Spare Parts Requirements for High-Voltage Battery – Observe Additional Measure Required (34/21)

Model Line: **Taycan (Y1A, Y1B, Y1C)**

Concerns: **Damping elements for high-voltage battery**

Front damping elements

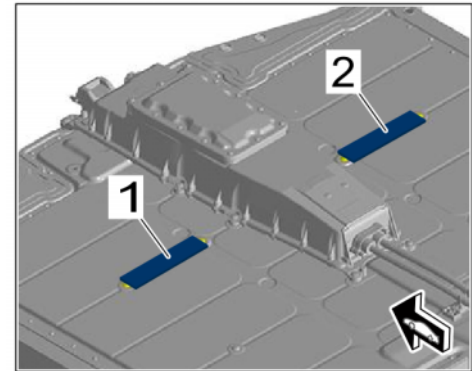
Work procedure: 1 Check whether damping elements are installed on the high-voltage battery at the front left ⇒ *Front damping elements -1-* and right ⇒ *Front damping elements -2-*.

New damping elements must **not** be affixed if damping elements were not previously affixed. Otherwise, the high-voltage battery or underbody could be damaged.

Front left damping elements

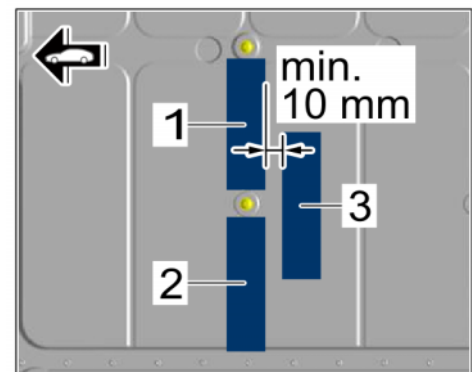
2 Stick three damping elements (177 x 60 x 3 mm/ 6.97 x 2.36 x 0.12 in) flush with each other. Three damping elements (element = stack of 3 pads) are then to be installed on each side of the high-voltage battery, even if only one damping element was affixed on each side of the old high-voltage battery.

- All sections of pads will be in stacks of 3 (will be 9mm/ 0.36 in thick when stacked together)
- This means 9 pads are used on each side; 18 per battery.

3 Position the first damping element ⇒ *Front left damping elements -1-* in the middle between the screws and stick it on.

- Never affix damping elements over the screws as they must remain accessible.
- The damping elements must be pressed into existing depressions and pressed on all the way around.
- The individual damping elements must be **at least 10 mm/ 0.39 in** apart.

4 Position the second damping element ⇒ *Front left damping elements -2-* at the left next to the screw and stick it on.

- 5 Position the third damping element ⇒ *Front left damping elements -3-* in the middle under the screw and stick it on.
- 6 Repeat these steps for the right side.
